ACEEE Regulatory Comments
American Council for an Energy-Efficient Economy

Comments of the American Council for an Energy-Efficient Economy (ACEEE) on NHTSA and EPA's Notice of Proposed Rulemaking "Safer Affordable Fuel-Efficient (SAFE) Vehicles Rule for Model Years 2021-2026 Passenger Cars and Light Trucks" (Docket No. EPA-HQ-OAR-2018-0283 and NHTSA-2018-0067)
Submitted via Regulations.gov

October 2018

Figure 1. Augural standard CO2 benefits lost by adopting technology incentives

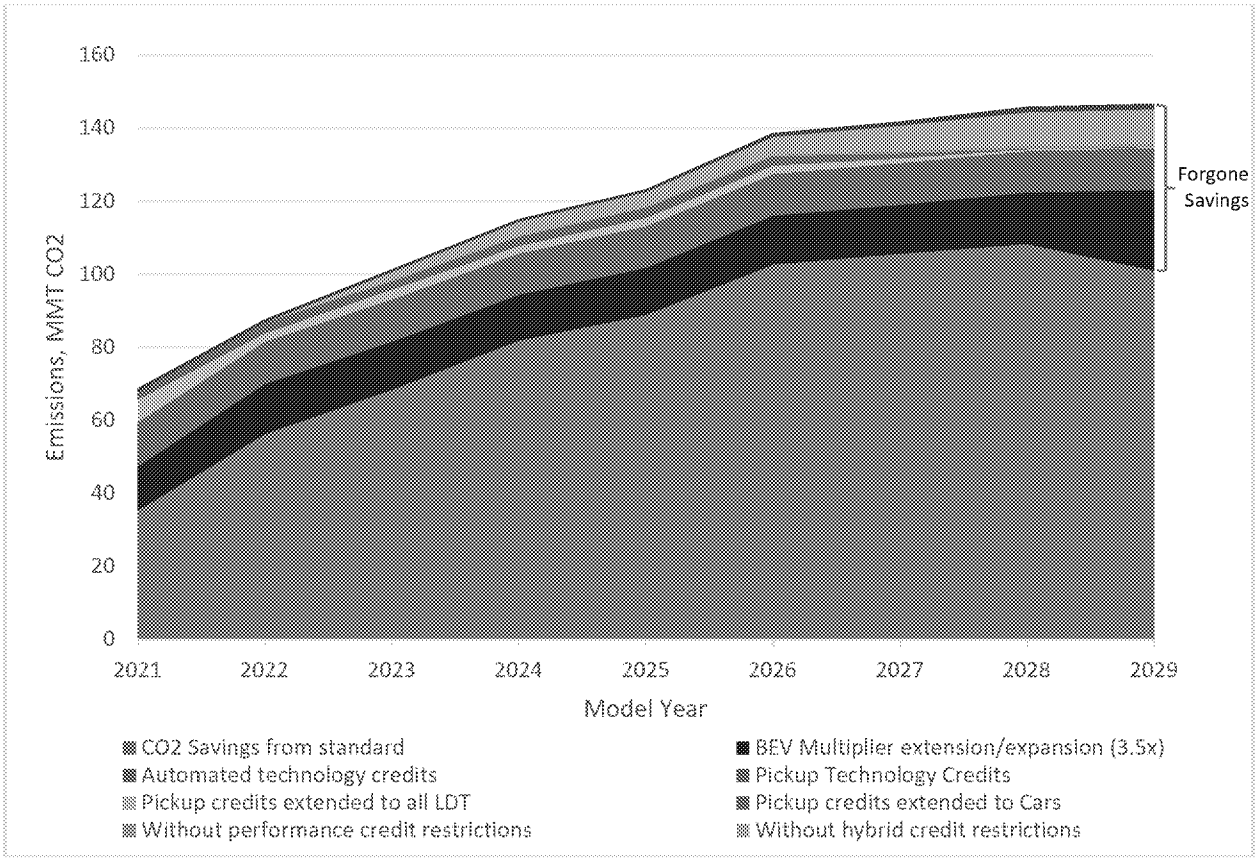
The changes to technology incentives on which EPA requests comment have the potential to reduce substantially the savings of CAFE and GHG emissions standards, as shown in figures 1 and 2. We find that, based entirely on the projected fleet under agency modeling for this NPRM, such incentives would increase real-world CO2 emissions by 320 MMT over the lifetimes of MY 2021-2029, eliminating nearly 30% of the benefit of the augural standard. For reasons explained elsewhere in these comments, we do not believe the agencies' compliance scenario to be a realistic portrayal of the technology mix that would be required to achieve the augural standard but it serves nonetheless to demonstrate the magnitude of possible effect of ill-considered changes to the credit programs. If these potential incentives worked as intended to increase penetration of the included technology beyond that shown in the agencies' compliance scenario, an even greater share of the total benefits could be lost.

Figure 2. Increased CO2 emissions due to new credits awarded under 0% per year proposed alternative scenario in CAFE model.

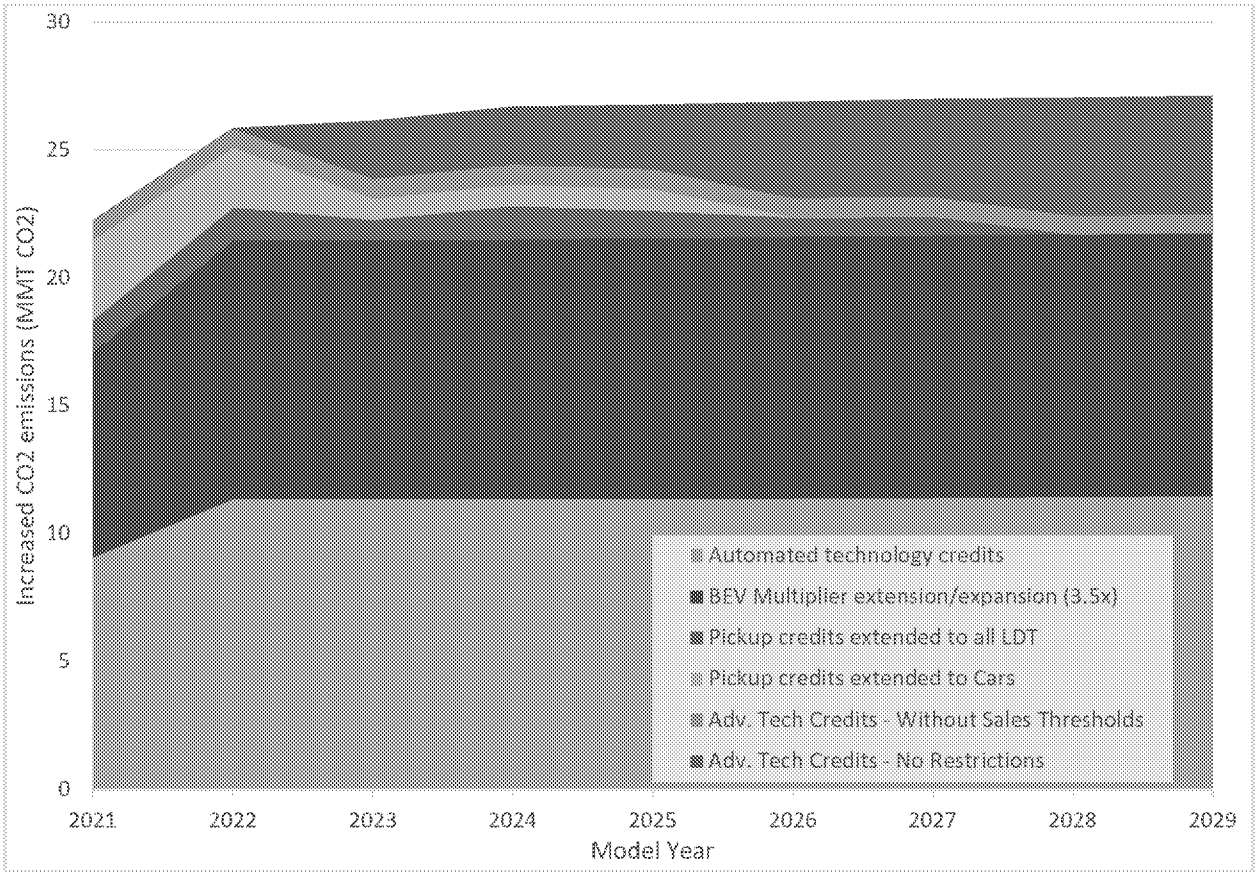
Under the agencies proposed alternative, providing these technology incentives would lead to an increase in CO2 emissions in addition to that realized by rolling back the standard, as shown in figure 2.
